REPLACEMENT PLUTONIUM CONCENTRATION EQUIPMENT - PUREX
DEFINITION OF SCOPE

REPLACEMENT PLUTONIUM CONCENTRATION EQUIPMENT - PUREX
DEFINITION OF SCOPE

- References: 1. HW-45168, "Preliminary Project Proposal - L Cell Equipment Replacement, Purex", by DA Snyder, November 15, 1956.
2. HW-45038, "Scope Design, Remote Equipment For Final Plutonium Product Concentration and Recovery in the Purex Plant", by HG Johnson, August 29, 1956.

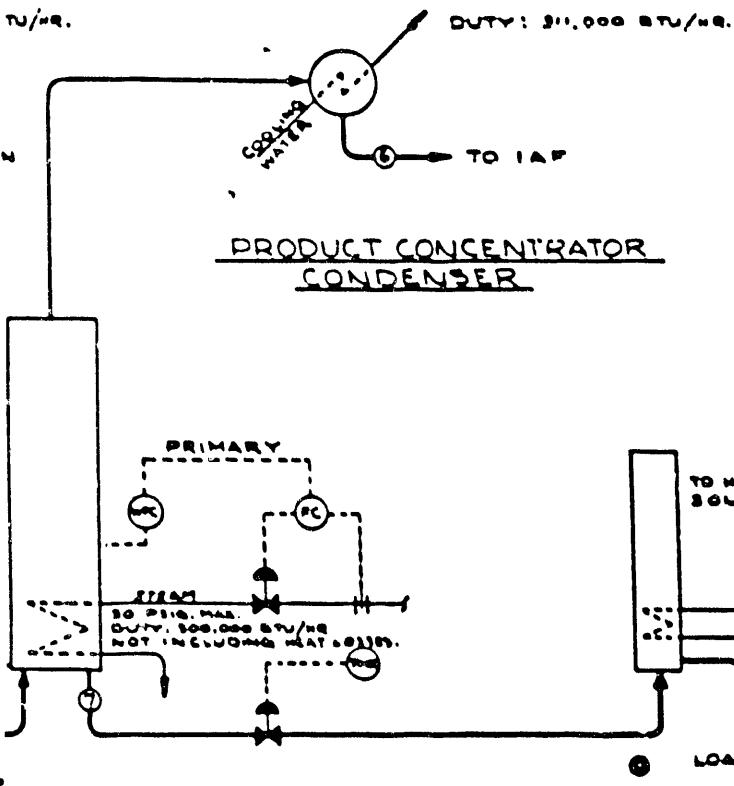
1. The acidity in the 2BP feed to the stripper was increased in order to increase the acid molarity of the concentrator product stream.
2. The alternate overflow line from the product concentrator to the product receiver was eliminated together with its associated specific gravity controller on steam to the concentrator.
3. Provisions were included to permit routing the prototype ion exchange product into the product concentrator for concentration.

1. The new process flow diagram, SK-2-2777, covering the flowsheet modification referred to above should be substituted for the process flow diagram, SK-2-2739, which was a part of the Reference 2 process design.
